Title of Change:	Documentation update for TO-252 Package Case Outline 369C and 369AA
Effective date:	09 Jul 2026
Contact information:	Contact your local onsemi Sales Office
Type of notification:	This Product Bulletin is for notification purposes only. onsemi will proceed with implementation of this change upon publication of this Product Bulletin.
Change Category:	Update note on case outline 369C & 369AA documents.
Change Sub-Category(s):	Datasheet/Product Doc change

PCN#: PB27433X
Issue Date: Jul 09, 2026

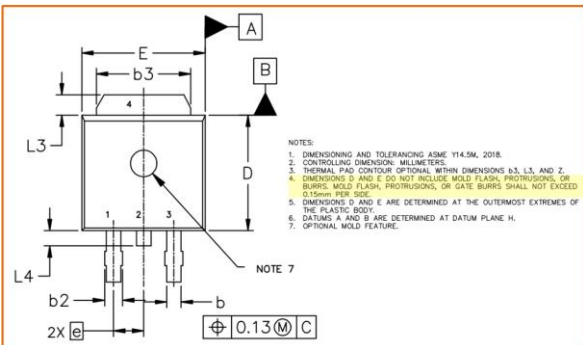
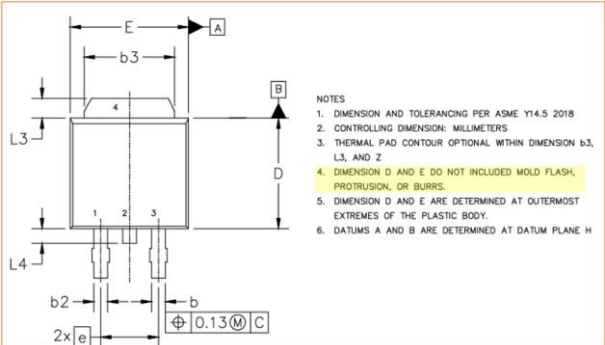
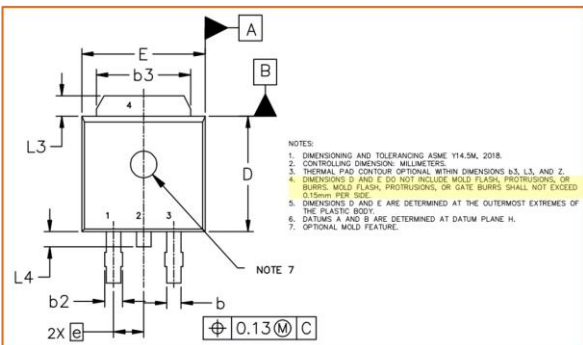
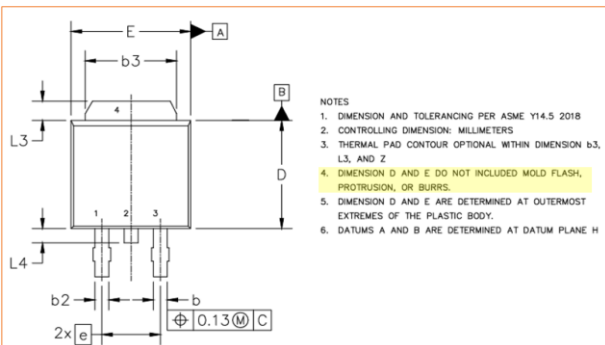
onsemi wishes to inform update note on case outline 369C & 369AA as description below:

Case Outline	From	To
Case 369C Note	4. DIMENSIONS D AND E DO NOT INCLUDE MOLD FLASH, PROTRUSIONS, OR BURRS. MOLD FLASH, PROTRUSIONS, OR GATE BURRS SHALL NOT EXCEED 0.15mm PER SIDE. 	4. DIMENSIONS D AND E DO NOT INCLUDE MOLD FLASH, PROTRUSIONS, OR BURRS. 
Case 369AA Note	4. DIMENSIONS D AND E DO NOT INCLUDE MOLD FLASH, PROTRUSIONS, OR BURRS. MOLD FLASH, PROTRUSIONS, OR GATE BURRS SHALL NOT EXCEED 0.006 INCHES PER SIDE. 	4. DIMENSION D AND E DO NOT INCLUDED MOLD FLASH, PROTRUSION, OR BURRS.

That's only change on documentation, it's not manufacturing change process.
